December 8, 2023

City of Stevenson  
Planning Commission  
C/o Ben Shumaker, City Planner  
7121 East Loop Road  
Stevenson, WA 98648

Subject: Rock Cove Hospitality Mitigation Addendum

Figure 1  
 EXISTING CONDITIONS  
 Rock Cove Addendum  
 FDM Development  
 City of Stevenson, Skamania County, Washington  
 Section 1, Township 2N, Range 7E, W.M.

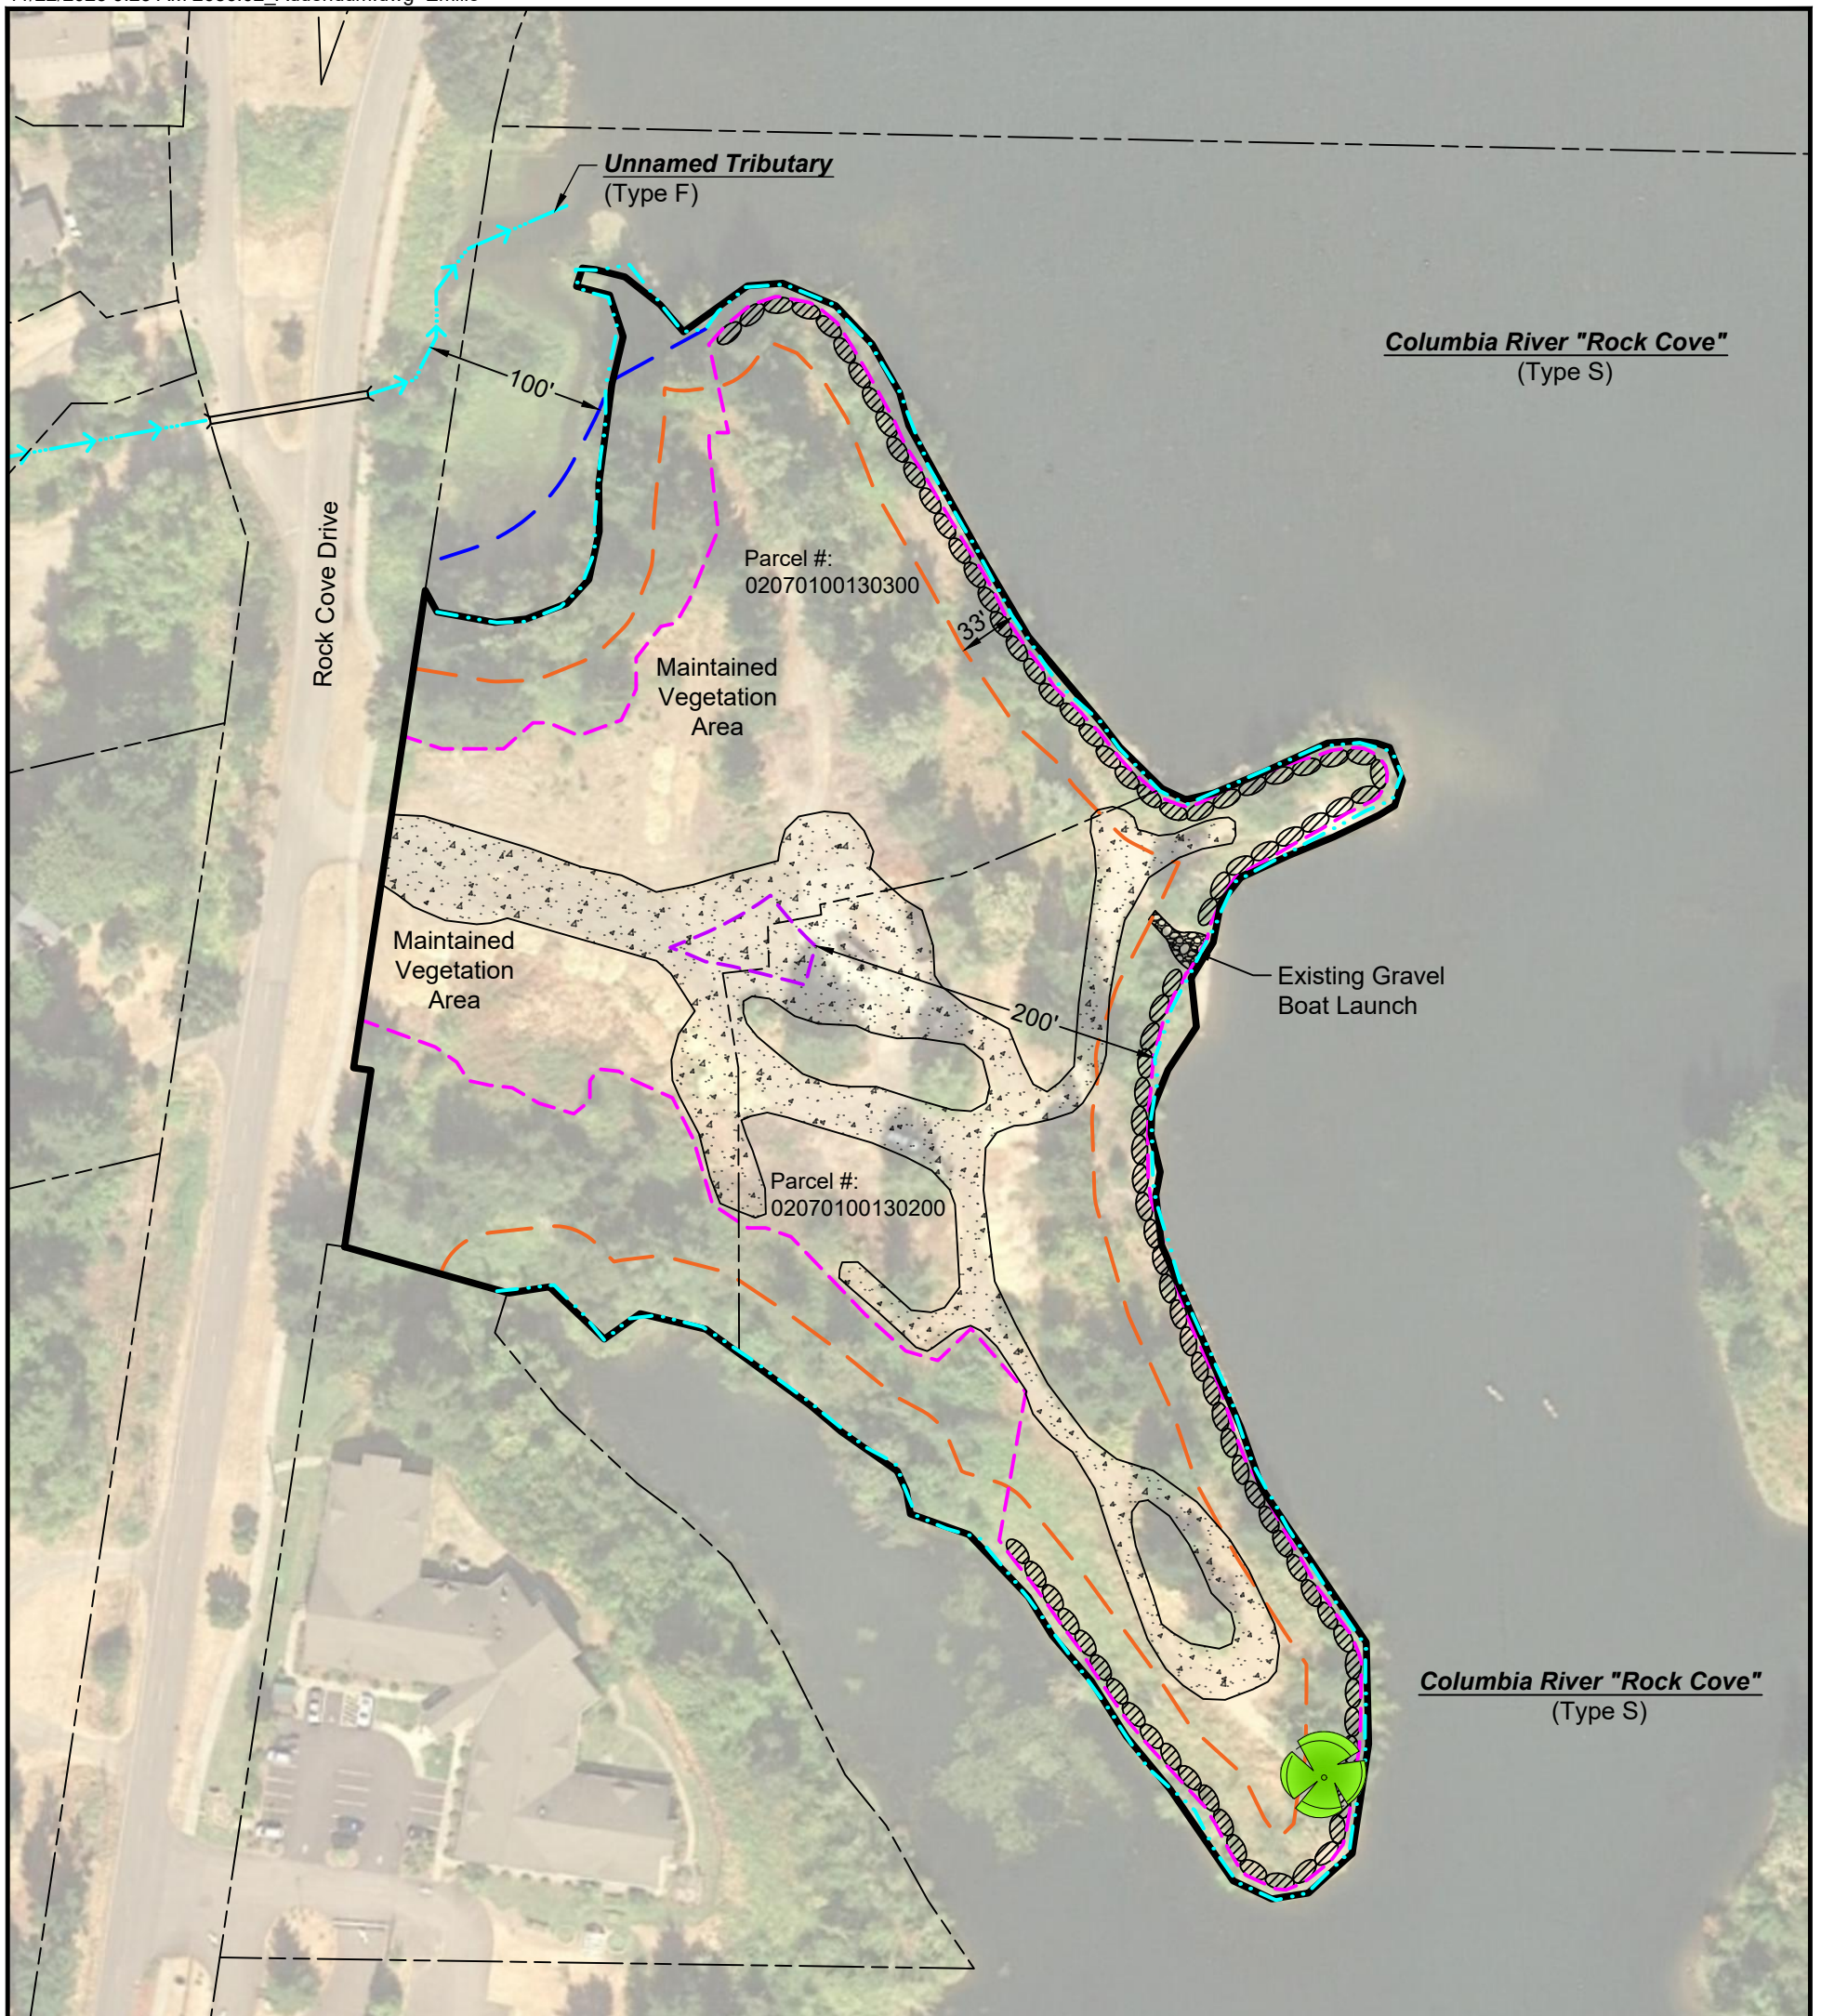
- *Ecology does not think the maintained vegetation areas shown in Figure 1 should qualify as functional isolation.*  
According to the SCO 18.13.095(D)(3), lawns and other mowed areas can be considered as functional separation from FWHCA buffers. These areas have been mowed and maintained since the year 2000 as can be seen on Google Earth aerial imagery. Additionally, these areas were photographed in January of 2020 in preparation of the original draft of the critical areas report by ELS (Photoplate 3 and 4). It is ELS' opinion that the provided evidence meets the requirement in the SCO and that these areas do indeed meet the definition of functional isolation.

Figure 3  
PROPOSED CONDITIONS - NOVEMBER 2023  
Rock Cove Addendum  
FDM Development  
City of Stevenson, Skamania County, Washington  
Section 1, Township 2N, Range 7E, W.M.

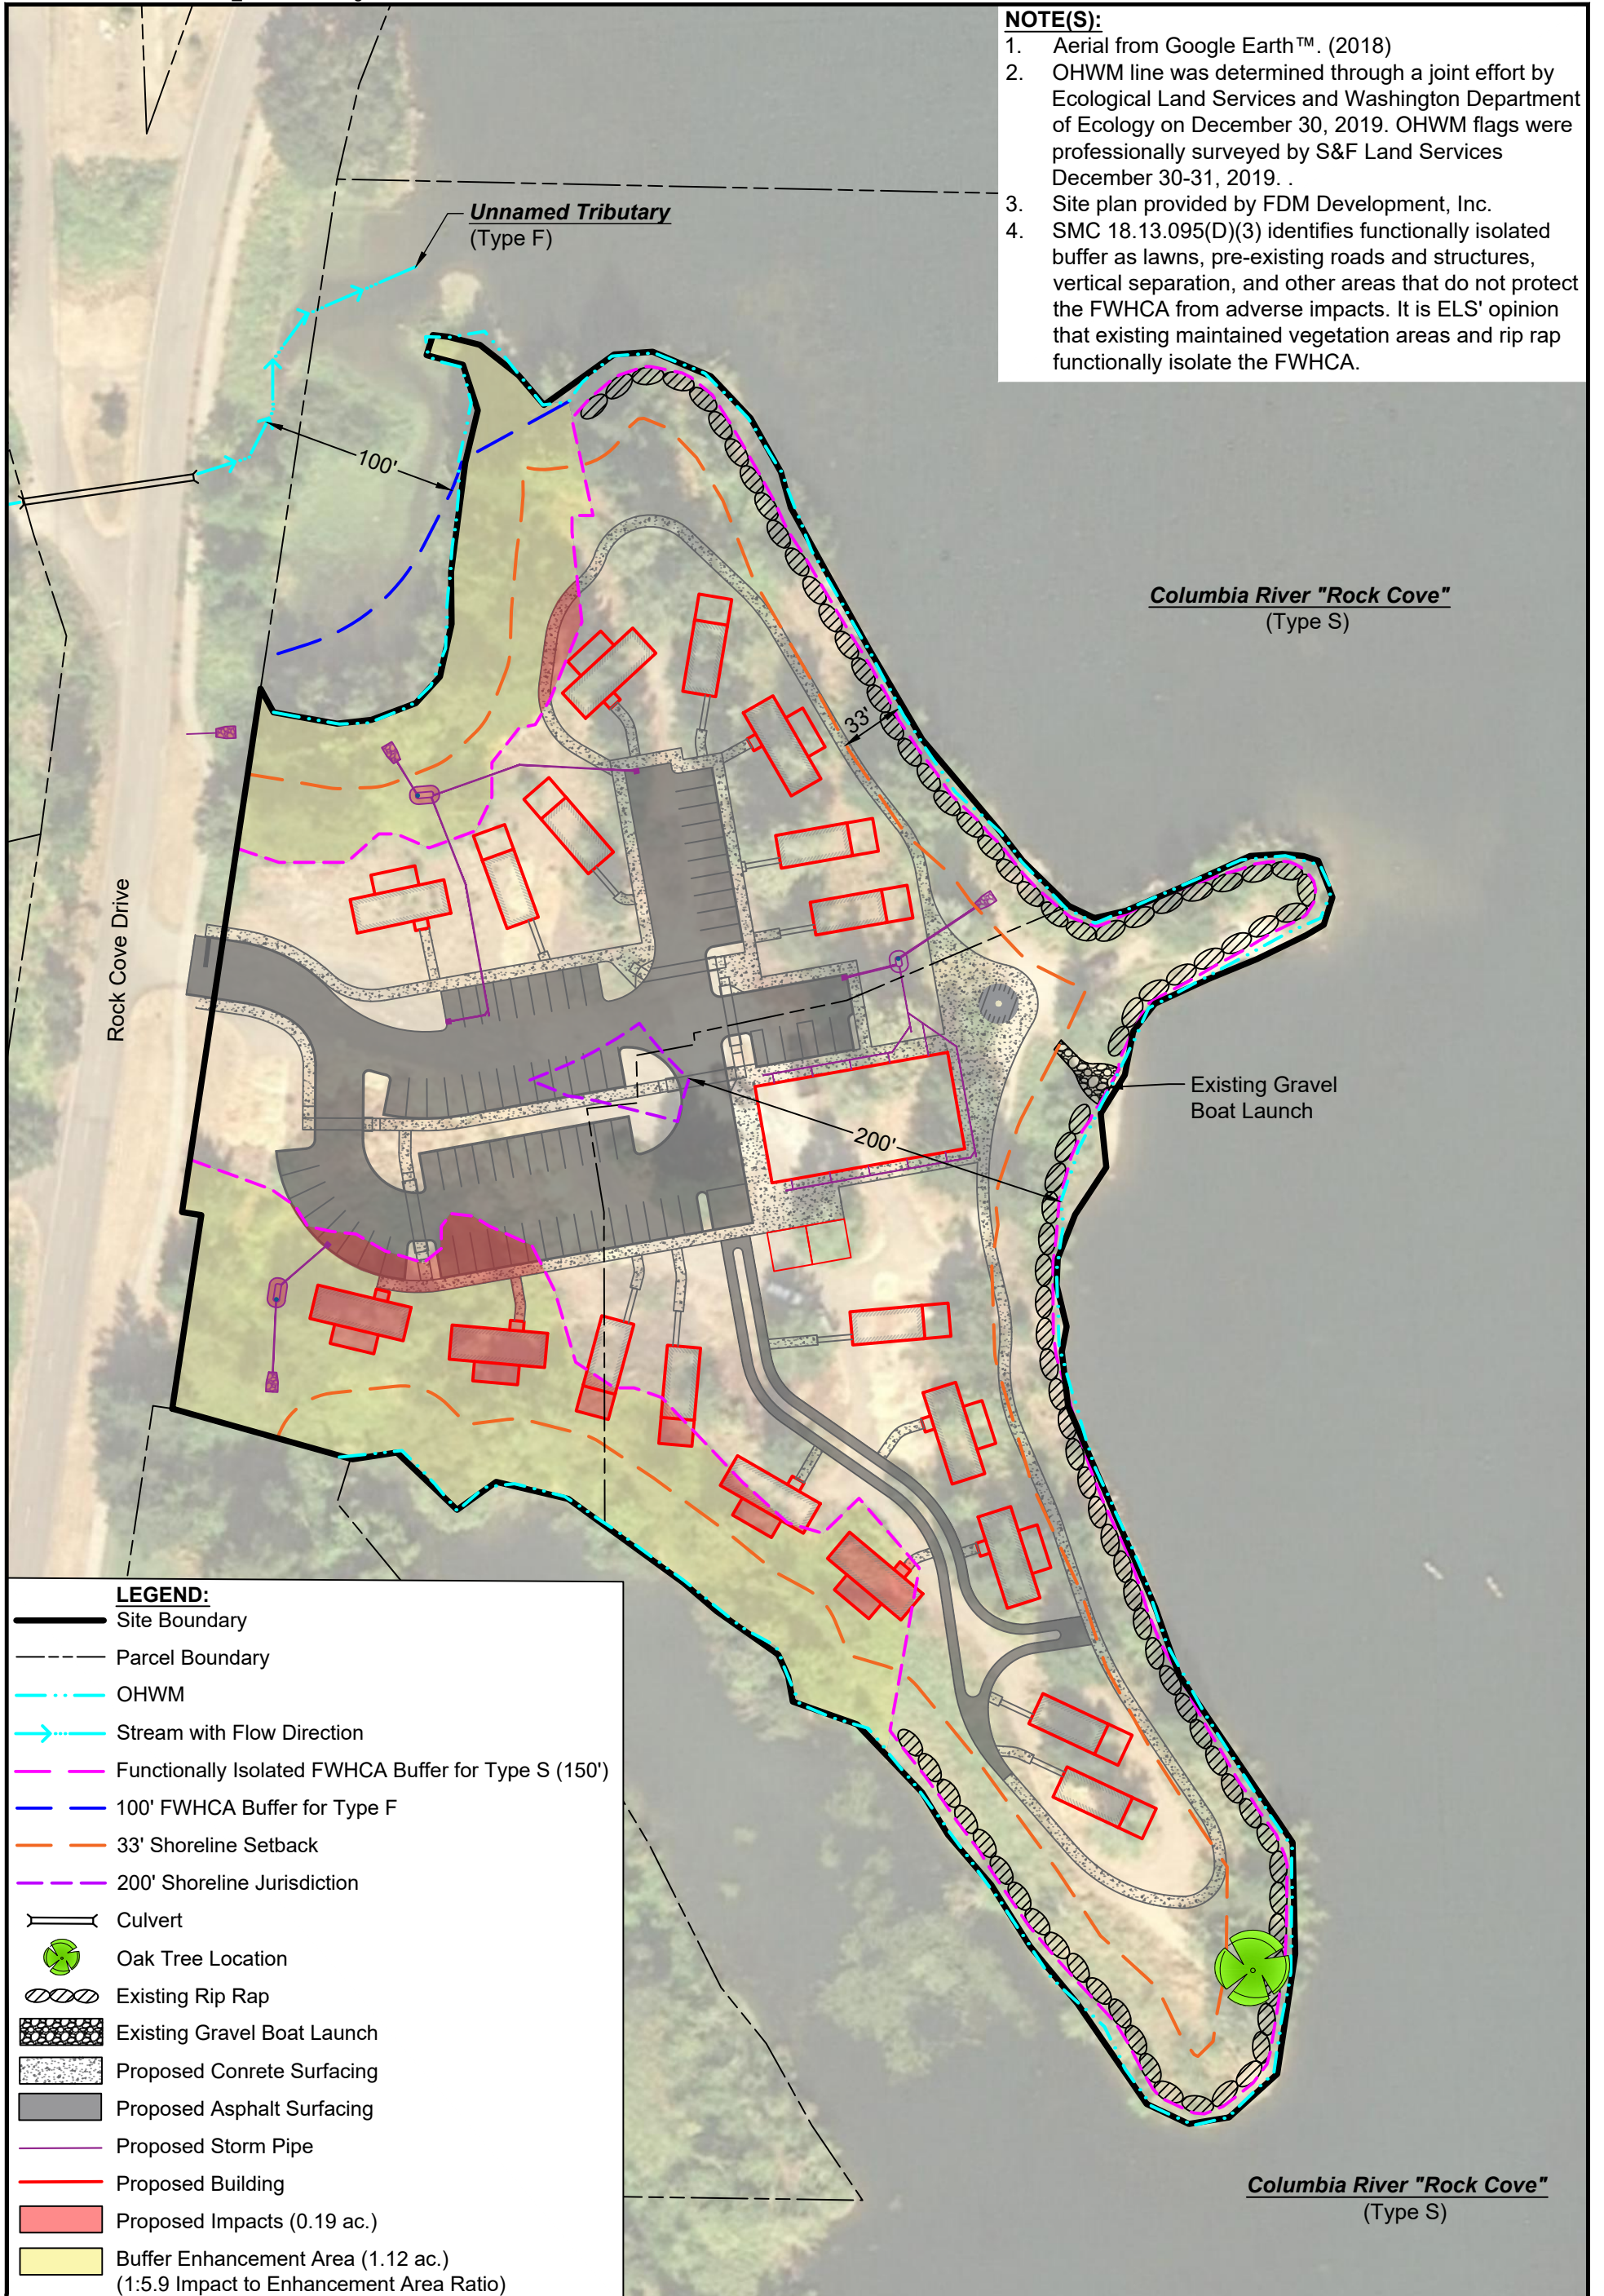
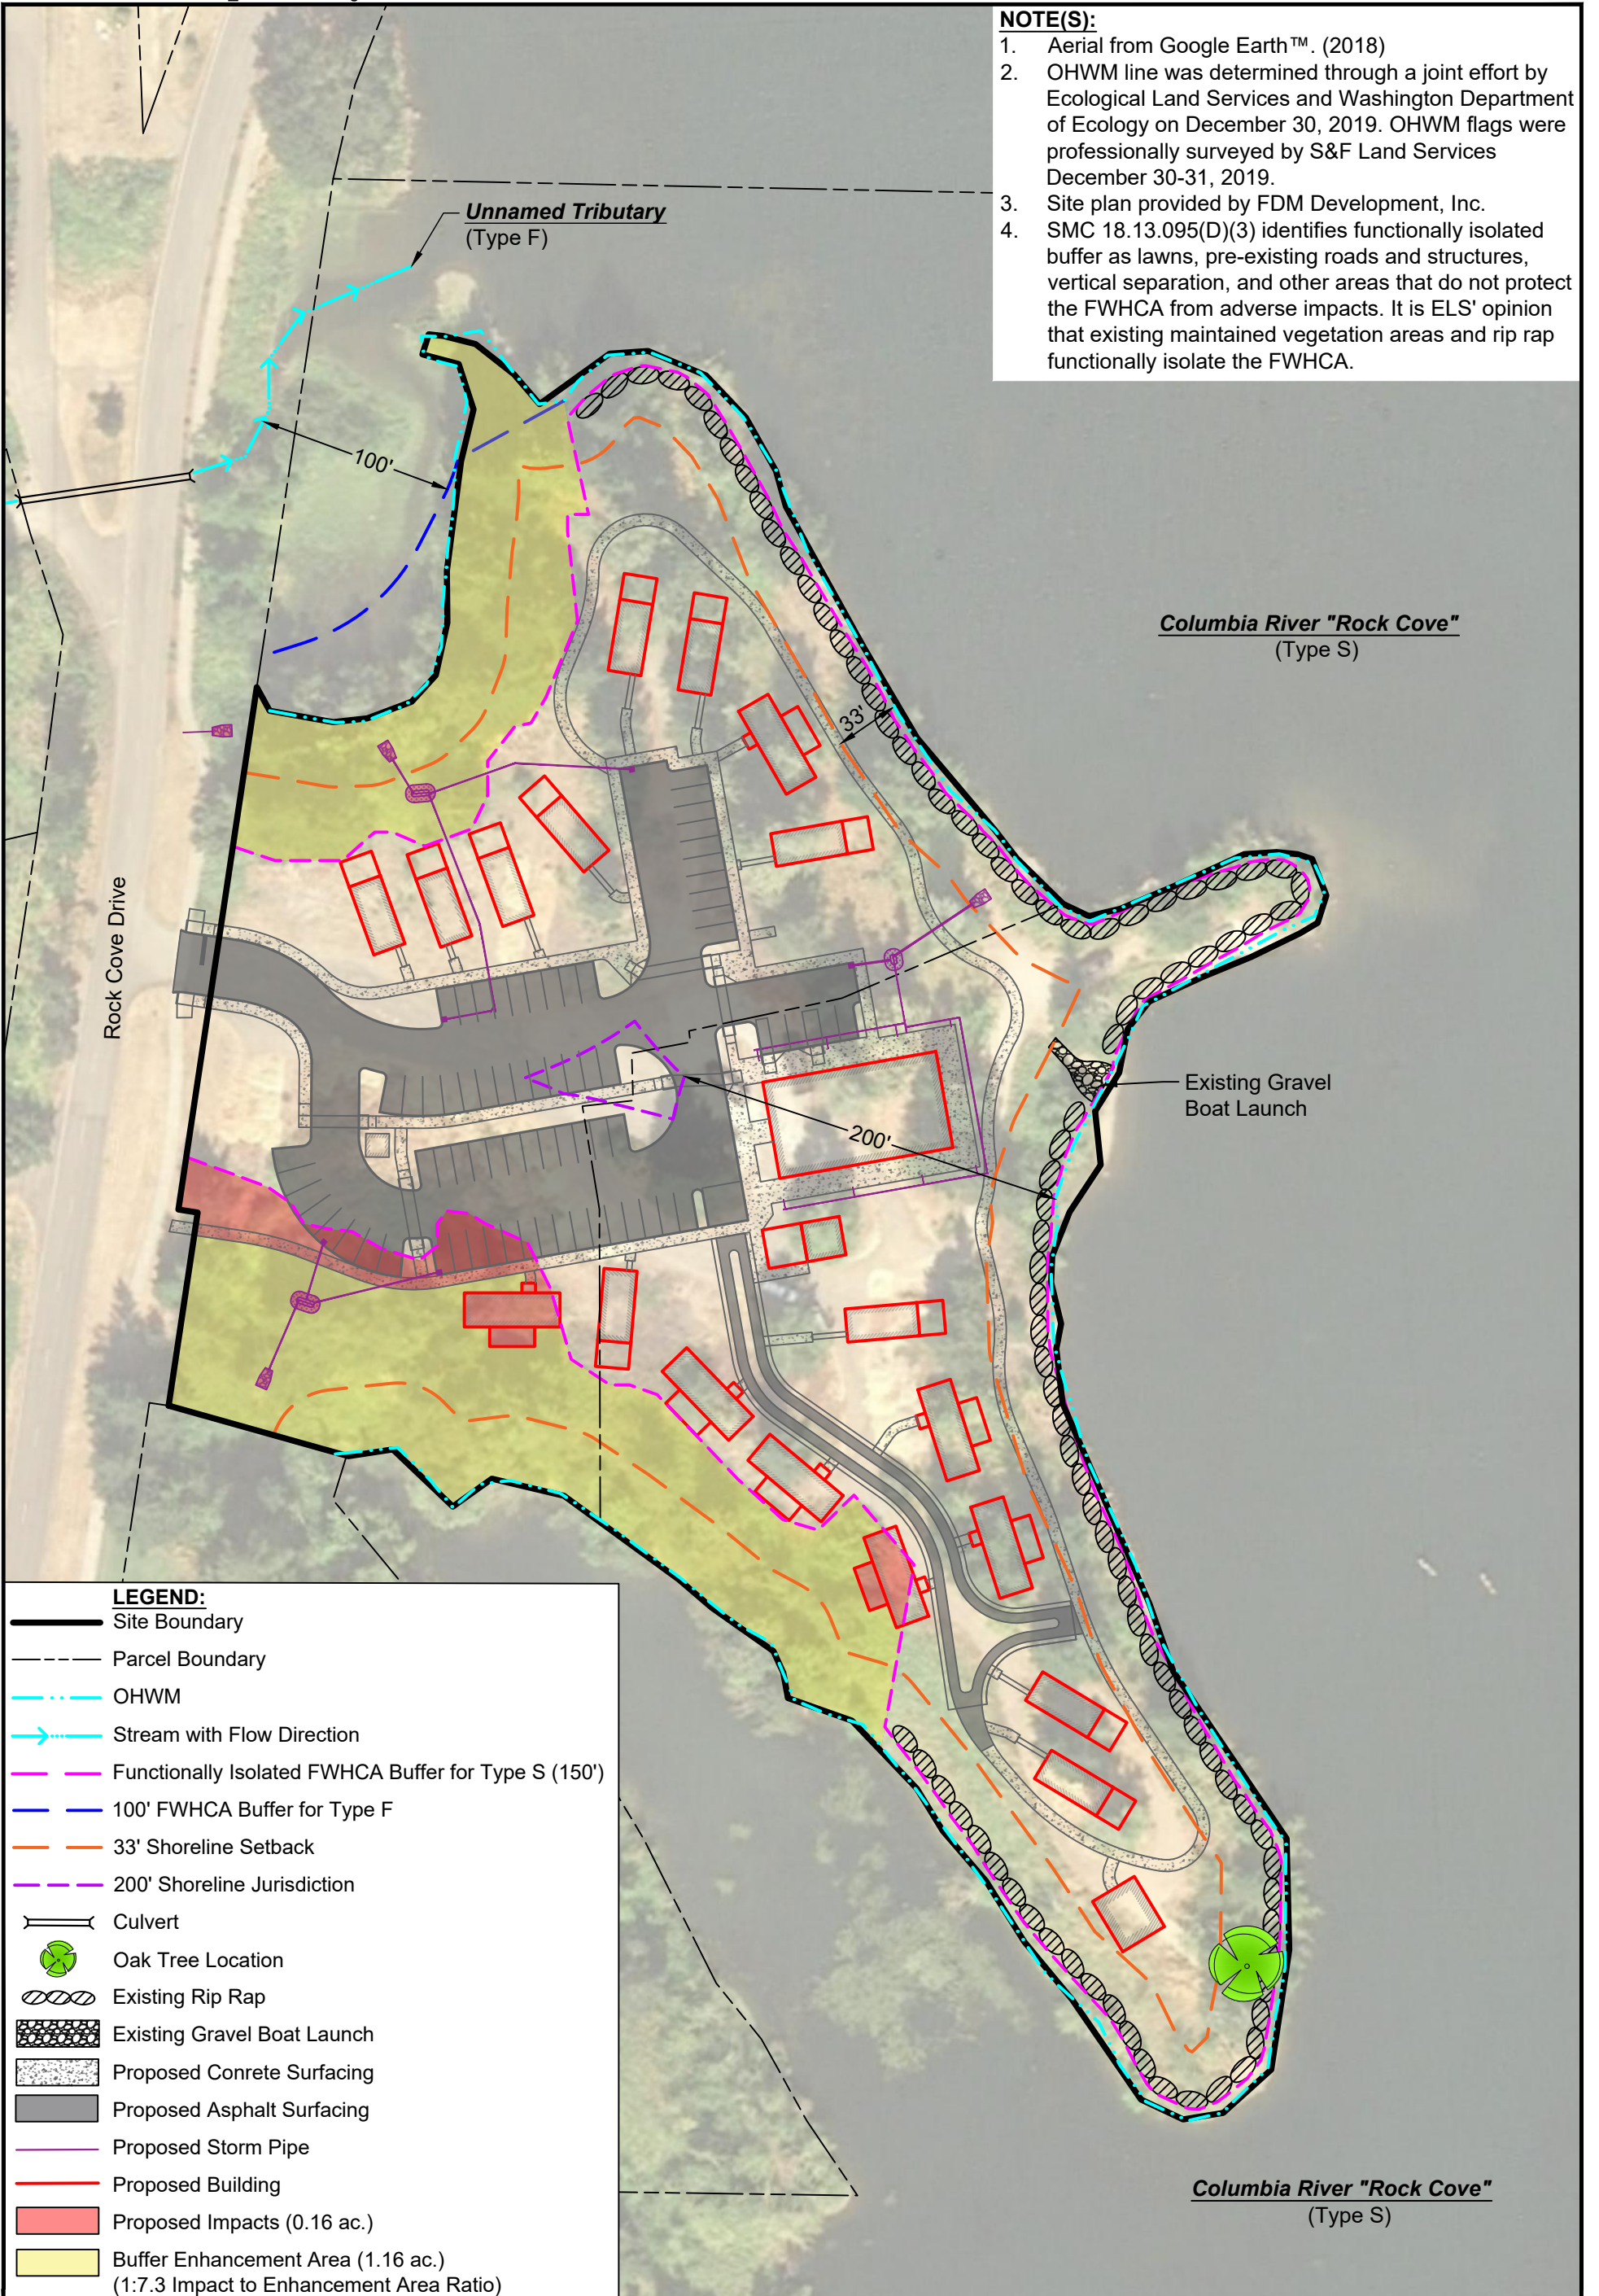
- *Ecology states that vegetation removal within shoreline jurisdiction requires mitigation at the mitigation ratios listed in the SMP Table 6.2*  
A nominal quantity of shrubs will be removed from the impact areas shown on Figure 3. These shrubs consist of native groundcover and understory, non-native vegetation, and invasive species such as Himalayan blackberry. According to Table 6.2 of the SMP, the required mitigation ratio is 1:1 for these vegetation types. A total of \$5,280 (the cost for 0.16 acres at \$33,000 per acre) will be paid to the Lower Columbia Fish Enhancement fund to compensate for the 0.16 acres of impacts to the FWHCA which lie within shoreline jurisdiction.
